**TRANSMITTAL OF RESPONSES TO THE OHIO ENVIRONMENTAL PROTECTION
AGENCY COMMENTS ON THE DRAFT AREA 9, PHASE III ABANDONED
OUTFALL LINE EXCAVATION PLAN- PART THREE**

**RESPONSES TO
OHIO ENVIRONMENTAL PROTECTION AGENCY
COMMENTS ON THE DRAFT AREA 9, PHASE III
ABANDONED OUTFALL LINE
EXCAVATION PLAN – PART THREE**

**RESPONSES TO OHIO ENVIRONMENTAL PROTECTION AGENCY COMMENTS
ON THE DRAFT AREA 9, PHASE III ABANDONED OUTFALL LINE – PART THREE
(21140-PL-0004, REVISION A)**

AREA 9 PHASE III
REMEDIATION OF ABANDONED OUTFALL LINE
PIPE REMOVAL UNDER ST. RT. 128
PROJECT: 2920
DATE: 10/28/2004
DRAWN: R.M. LINDGREN
99X-5500-G-00822 A

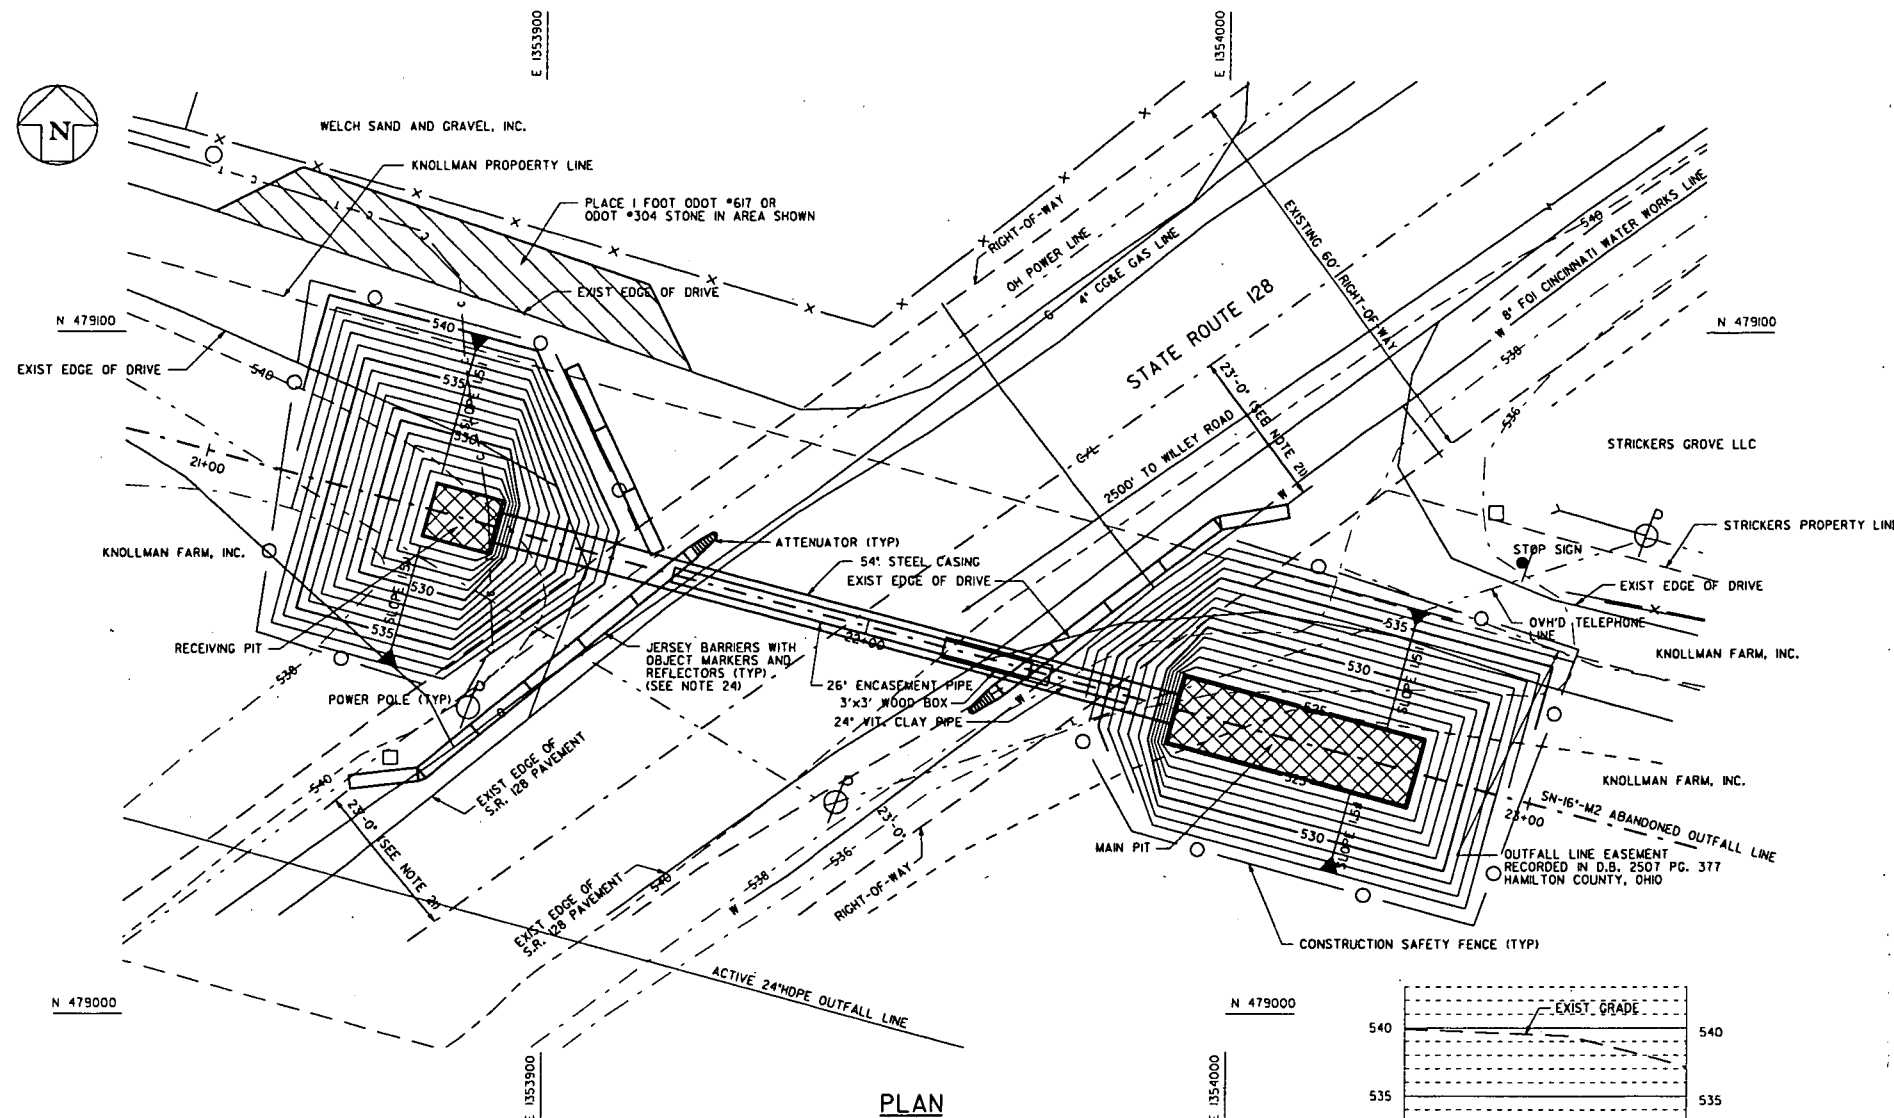
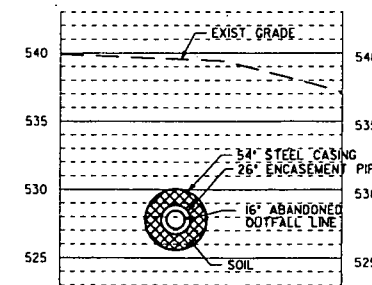
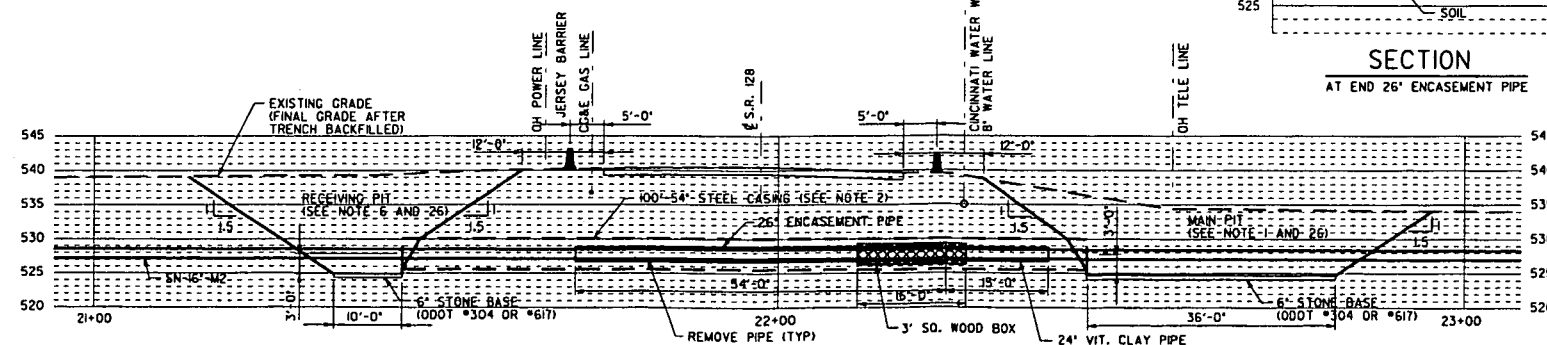
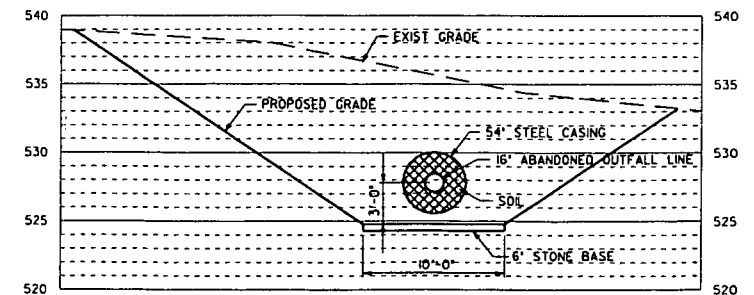
5. Commenting Organization: Ohio EPA Commenter: OFFO
 Section #: 3.3.7 Pg #: 3-10 Line #: 27-28 Code: C
 Original Comment #: 5
 Comment: This section states that the superficial fill material located between the pipe and the casing will be removed. Please provide details on how this superficial fill will be removed.

11. Commenting Organization: Ohio EPA Commenter: OFFO
Section #: Drawings Pg #: G-10 Note #: 1 Code: C
Original Comment #: 11
Comment: This note under this Removal of AOL Under SR 128 states that the steel casing pipe, which is to be left in place will be extended to the ODOT right-of-way. This is not mentioned in the Excavation Plan. Please explain the reasoning behind this and provide details in the plan on how this will be accomplished.

Action: Section 3.3.7 of the Excavation Plan will be revised to reflect casing pipe method for removal of the AOL under State Route 128 and to provide additional detail. In addition, a new drawing (99X-5500-G-00822 – Area 9, Phase III Remediation of Abandoned Outfall Line Pipe Removal Under St. Rt. 128) will be added to the construction drawings that will also reflect the casing pipe method for removal of the AOL under State Route 128 (see Attachment B to these comment responses for revised Section 3.3.7 and additional drawing).

- Action: Section 3.3.7 of the Excavation Plan will be revised to reflect the casing pipe method for removal of the AOL under State Route 128. In addition, a new drawing (99X-5500-G-00822 - Area 9, Phase III Remediation of Abandoned Outfall Line Pipe Removal Under St. Rt. 128) will be added to the construction drawing package that also will reflect the revised methodology for removal of the AOL under State Route 128 (see Attachment B to these comment responses for modified text). The detail on drawing 99X-5500-G-00809 (sheet G-10) will be deleted.
